Title		
Size	Number	Revision
A2		
Date:	2019-11-23	Sheet 6 of 6
File:	C:\Users\JEFG\Documents\EEG_schematic.SchDoc	Drawn By:

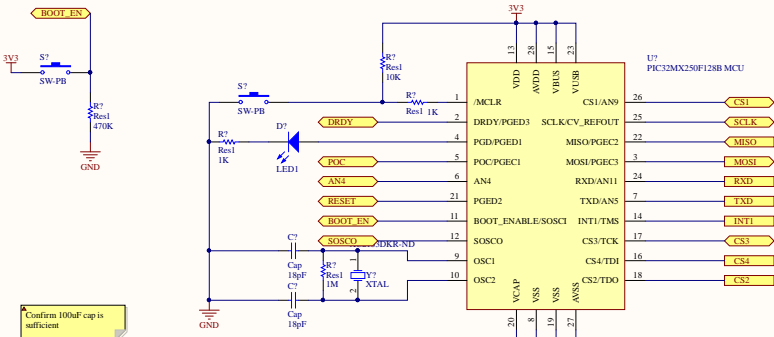
Bias amp Note:

- if bias amp not used, can float pin 61, 62, 63 (pg. 61)
- Unnecessary for milstone 2, but for future...
- Bias amp used to reduce common mode noise (pg. 68)
- OpenDrCl resistors and caps for bias network are connected differently than in the database: for e.g. bias amp has NF network to BIAS_INV in datasheet
- Would need a way to determine resistor capacitors for bias amp, database does not give concrete values -> contact TI applications engineer?

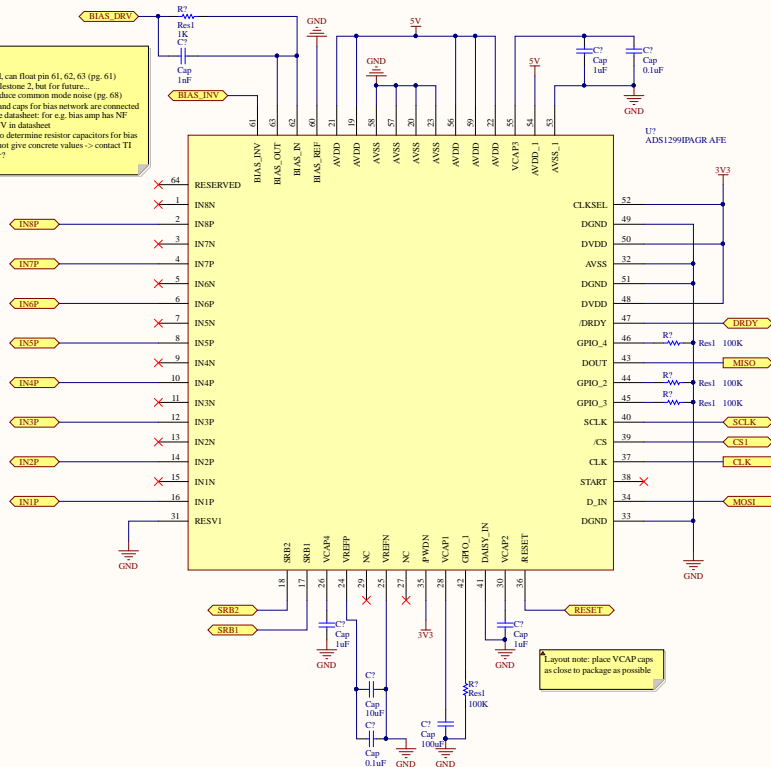
4.7uF input cap is a place holder. Investigate it's effect on ripple

Confirm 100nF cap is sufficient

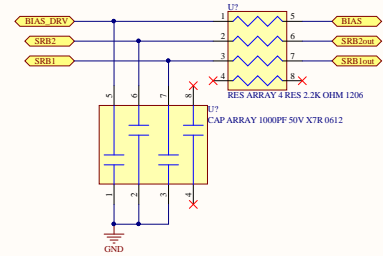
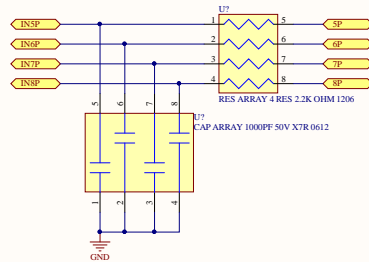
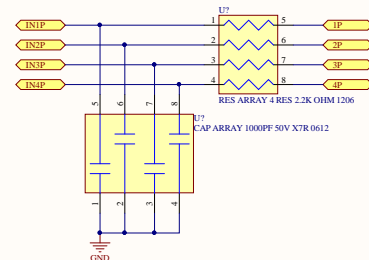
Probably could use a header with less pins since N pins are NC'd

Electrode RC network note:

- Using referential montage setup as in DS (pg 67)
- Using initial RC values based on OpenDrCl values (may need to change these in the future)
